SPB Number: 2022.0302

RCP-LIGHTING UPDATE

Issued: 10/20/2022

STANDARD PLAN BULLETIN NOTICE
RaceTrac Engineering and Construction Division

- Sheets: A300, A110, E001, E150 & E430
- Attachments: E150

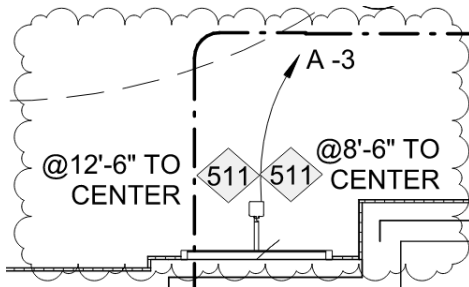
1. **REAR BANNER LIGHT:** Updated the rear banner light to be fixture type 511 and added power. Relocated the banners and light fixtures to be adjacent the rear entry.

- Sheet: A150
- Attachments: A150

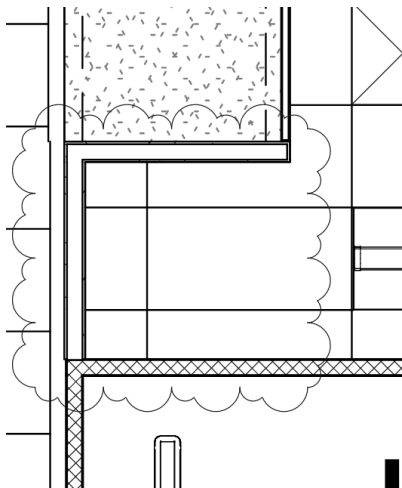
2. **BOH CEILING UPDATE:** Updated the ceiling in the BOH to be ACT in lieu of gyp. board ceiling.

- Sheets: A150 & A152
- Attachments: A150

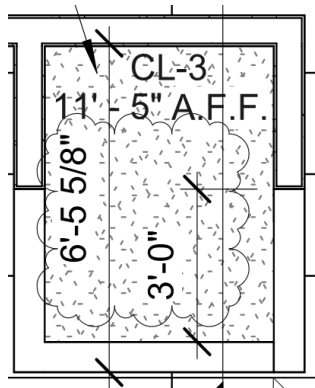
3. **WATER HEATER HEADER:** Updated the header to be 3'-0" away from the water heater.

- Sheet: A150
- Attachments: A150

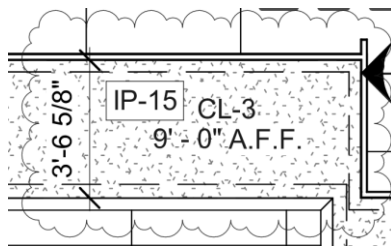
4. **FCB SOFFIT:** Removed the lower soffit above FCB.
